Proposed Turkey Point Units 6 and 7  
Docket Nos. 52-040 and 52-041  
FPL Revised Response to NRC RAI No. 02.05.02-3 (eRAI 5896)  
L-2013-305 Attachment 2 Enclosure A Page 1 of 3

**NRC RAI Letter No. PTN-RAI-LTR-037**

**SRP Section: 02.05.02 - Vibratory Ground Motion**

**NRC RAI Number: 02.05.02-4 (eRAI 5896)**

Figure 1. Shear Wave ( $V_s$ ) and Compression Wave ( $V_p$ ) Velocity Profiles for Sonic Log 0001

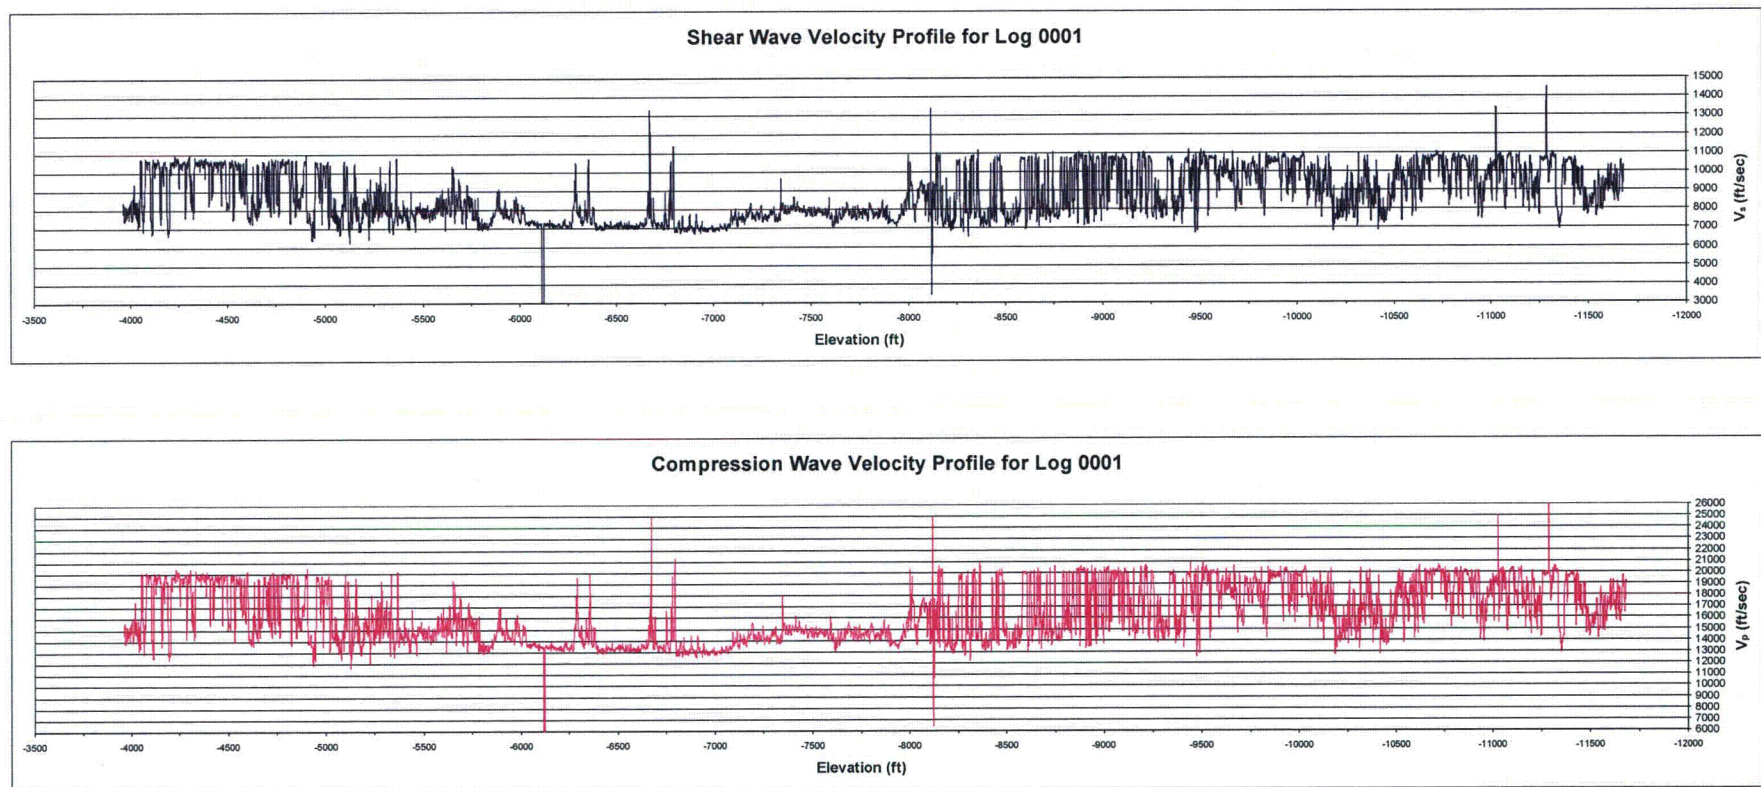
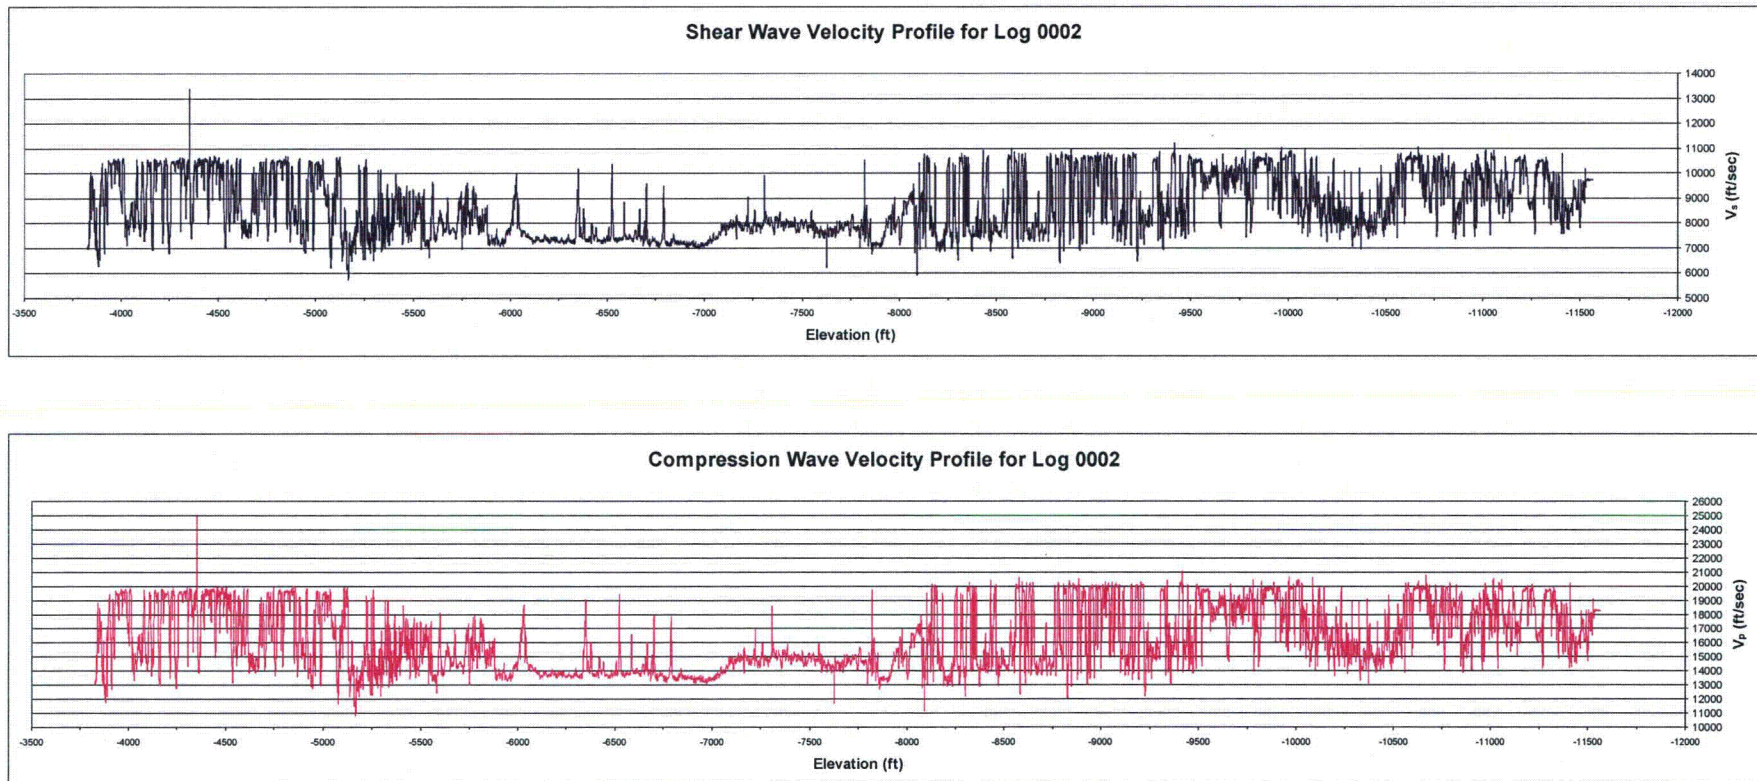
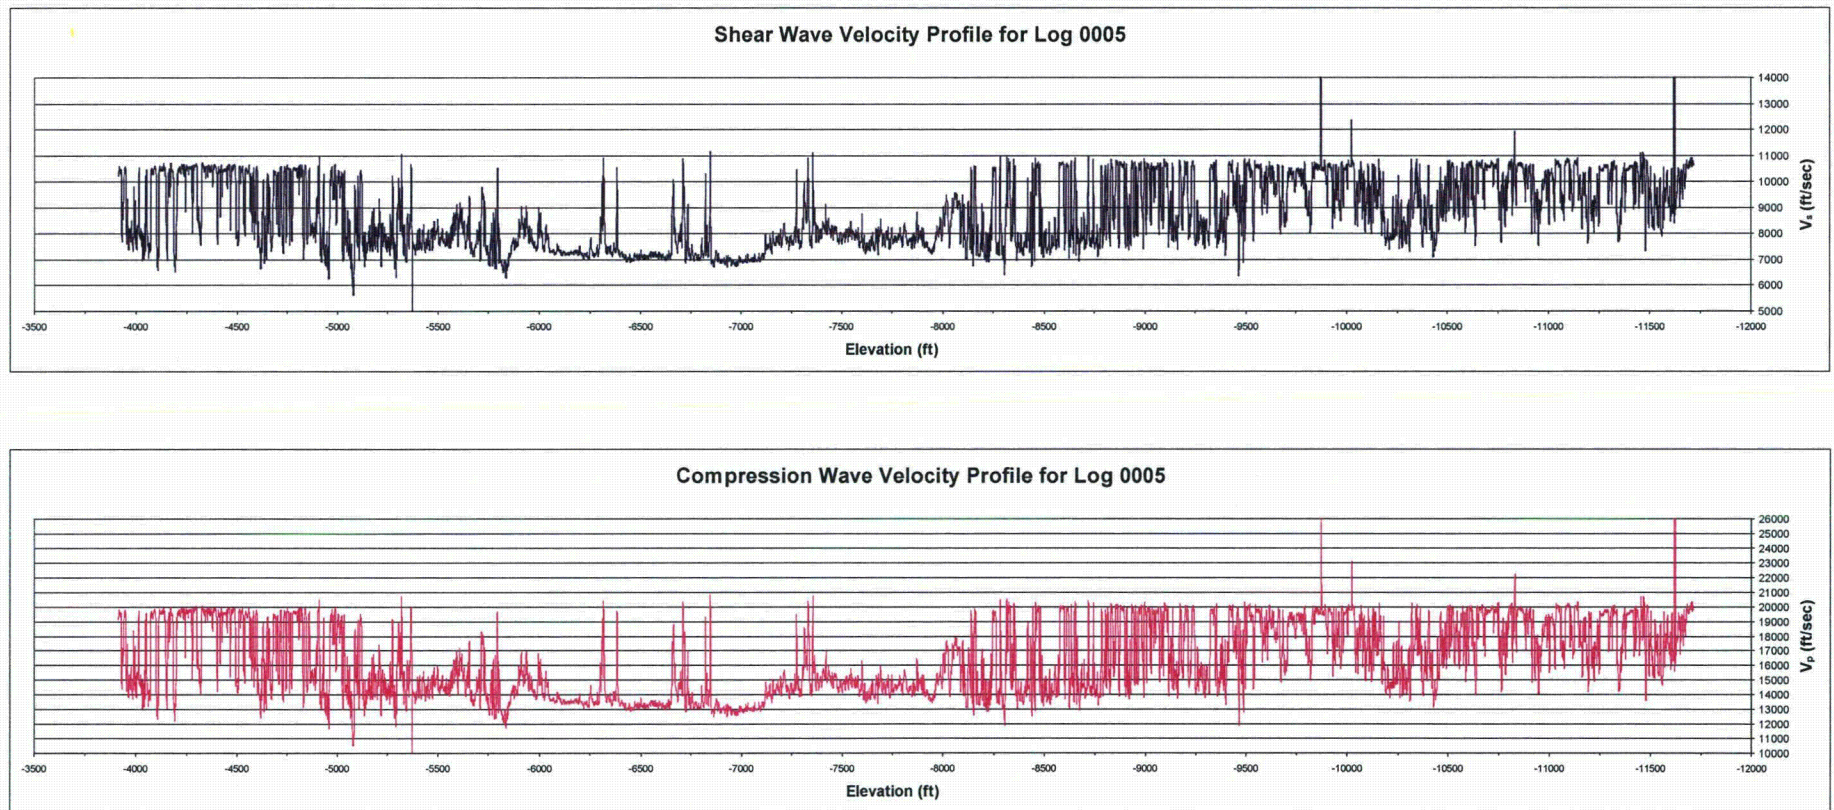
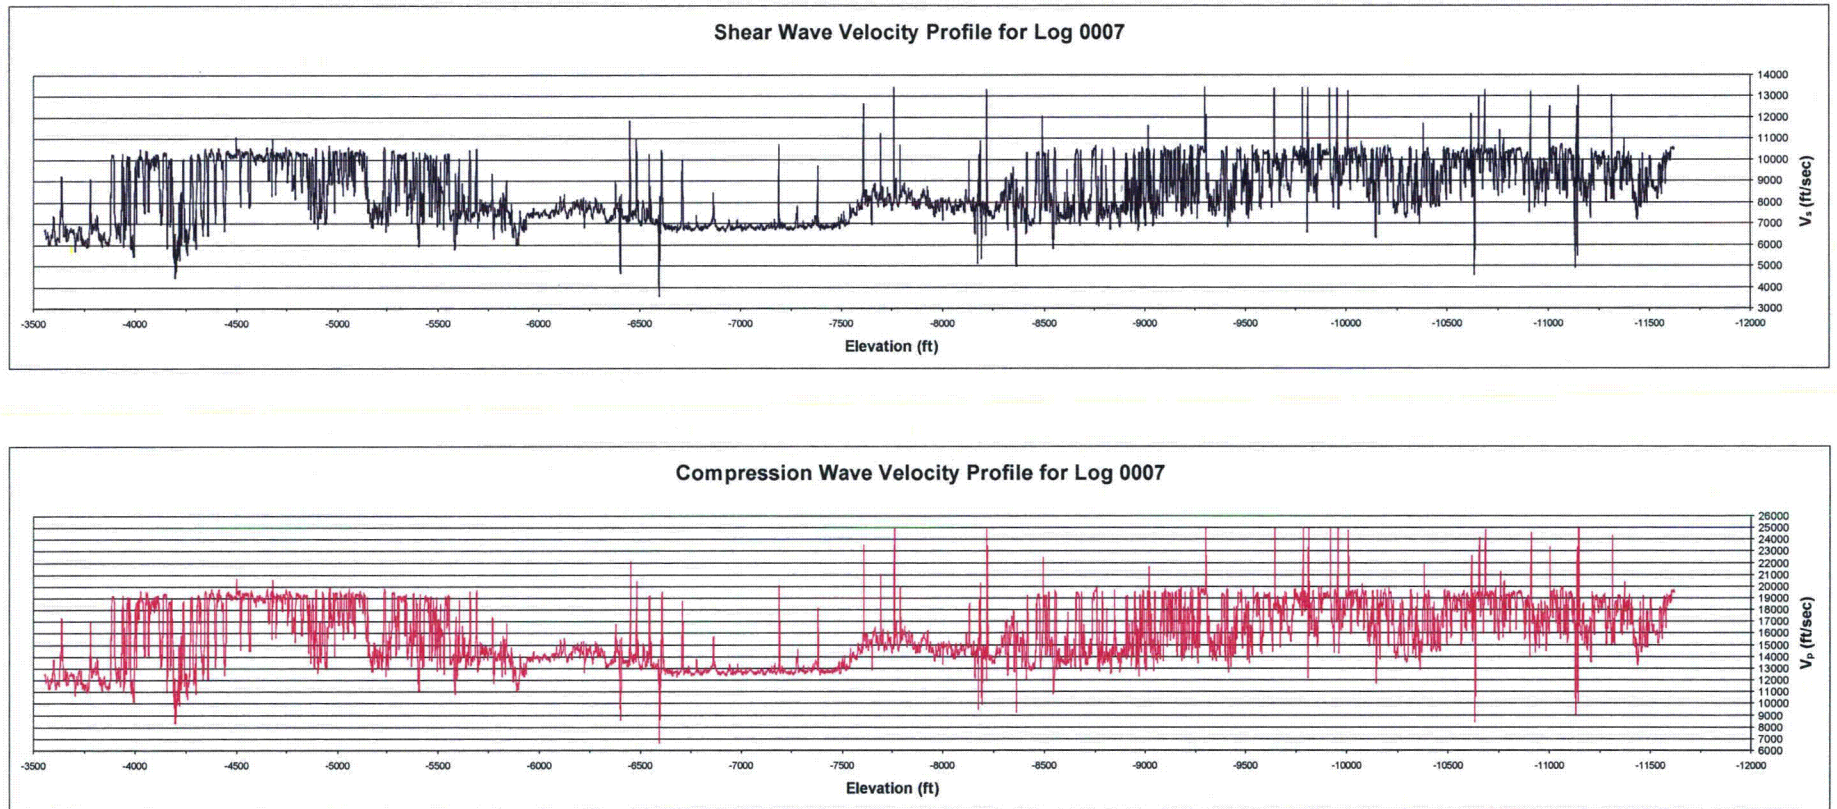
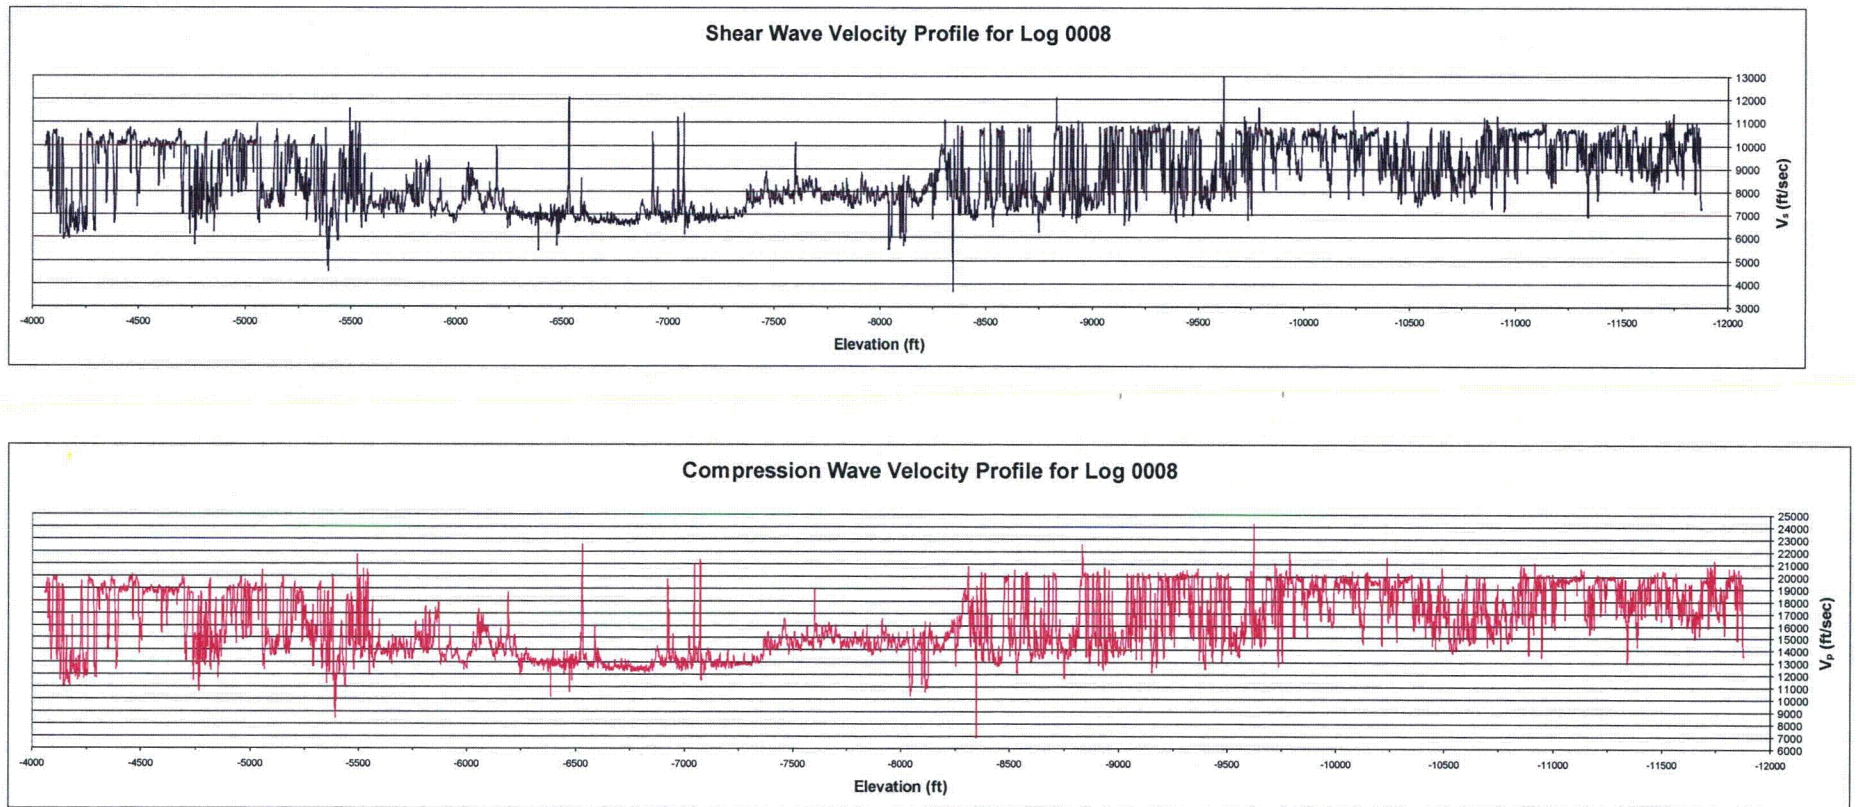
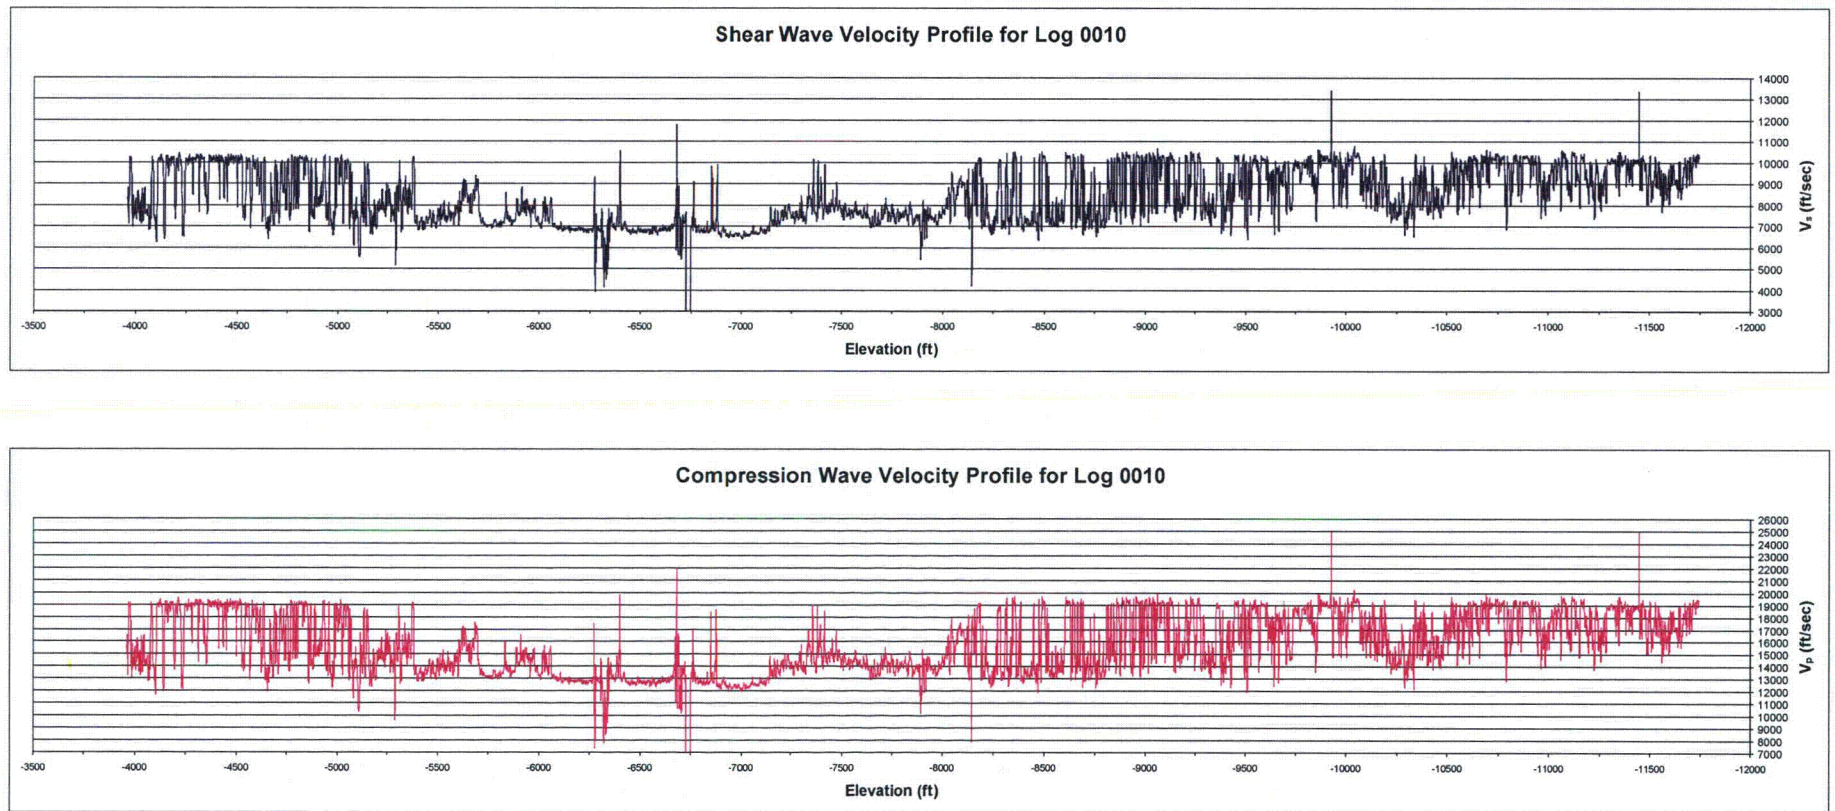
FSAR Subsection 2.5.2.5.1 states that P-wave velocities from eight deep wells were used to develop the deeper (>636 ft) sections of the site response model. The wells that provide the P-wave velocity information are approximately 100 km to 180 km away from the site. In accordance with Regulatory Guide (RG) 1.208, "A Performance-Based Approach to Define the Site-Specific Earthquake Ground Motion", please provide:

- a. additional information on the applicability of seismic velocity information obtained at such great distances to the Turkey Point site. How was the variation in geology considered in these projections?
- b. individual velocity profiles for each of the eight wells used in estimating the average profile shown in FSAR Figure 2.5.4-211
- c. further details on how larger uncertainties in deeper layers' thicknesses/depths are taken into account in the randomization of the site profile

Sonic logs 0001, 0002, 0005, 0007, 0008 and 0010 (files purchased from the Florida Geological Survey Division of Oil and Gas) were derived from wells located approximately 66 miles (approximately 106.2 kilometers), 62 miles (approximately 100.0 kilometers), 81 miles (approximately 130.4 kilometers), 110 miles (approximately 177.0 kilometers), 82 miles (approximately 132.0 kilometers), and 71 miles (approximately 114.3 kilometers) from the FPL Turkey Point site, respectively (FSAR Figure 2.5.4-210). The measurements recorded by the probe at these locations were depth, expressed in feet below the drill rig's Kelly bushing, and the interval travel time ( $\Delta T$  ( $DT_p$ )) expressed in microseconds ( $10^{-6}$  seconds) per foot. The logs were initiated at an upper depth of 3,610 to 4,100 feet (El. -3,555 to -4,059 feet NAVD 88) below each drill rig's Kelly bushing and terminated at a lower depth of 11,600 to 11,920 feet (El. -11,564 to -11,879 feet NAVD 88) below Kelly bushing.

Sonic logs LAB-TW and PBF-12 (Reference 1) were derived from wells located approximately 115 miles (approximately 185.1 kilometers) and 64 miles (approximately 103.0 kilometers) from the Turkey Point site, respectively (FSAR Figure 2.5.4-210). The measurements recorded by the probe at these locations were depth, expressed in feet

- a) The well locations with the sonic logs used for this analysis are shown on FSAR Figure 2.5.4-210. FSAR Figure 2.5.1-232 shows a north-south regional geologic cross section (Section E-F) through the Upper Mesozoic and Lower Cenozoic rocks in southern Florida. Point 39 on the cross section (and on the Inset Map on FSAR Figure 2.5.1-232) is the closest location on the regional geologic cross section to the majority of the sonic log locations on FSAR Figure 2.5.4-210. The distance from Point 39 to the Turkey Point site is about 80 miles (128.7 kilometers). Based on the review of publications (FSAR Subsection 2.5.1 References 374, 377, 378, and 397), regional geologic cross sections (FSAR Figures 2.5.1-232, 233, 235, and 236) and the sonic logs (0001, 0002, 0005, 0007, 0008, 0010, LAB-TW and PBF-12), there appears to be relatively little variation, on a regional scale, in the stratigraphy of the upper 6,000 ft between the Point 39 area and the Turkey Point site. Based upon this review the stratigraphic units generally show less variation with increasing depth. Therefore, it is reasonable to assume that the lack of stratigraphic variation on the scale shown in FSAR Figure 2.5.1-232 continues below 6,000 feet. The stratigraphic information and shear wave velocity data, which is calculated from Poisson's ratio and interval travel time derived from the sonic logs, were migrated down the gentle regional dip from the locations of the wells shown on FSAR Figure 2.5.4-210 to the Turkey Point Units 6 & 7 site. Geologic variations, where they exist, are most likely due to facies changes within the gross stratigraphic units. This regional geology-based approach is a reasonable means for developing a stratigraphic and shear wave velocity column for the stratigraphic units below the deepest site borings. This approach provides a technical basis for the development of the deep portion of the site response model. Variations in both unit thickness and material properties, that might be the result of facies changes within stratigraphic units, are accounted for by the randomization process described in part c of this RAI response.
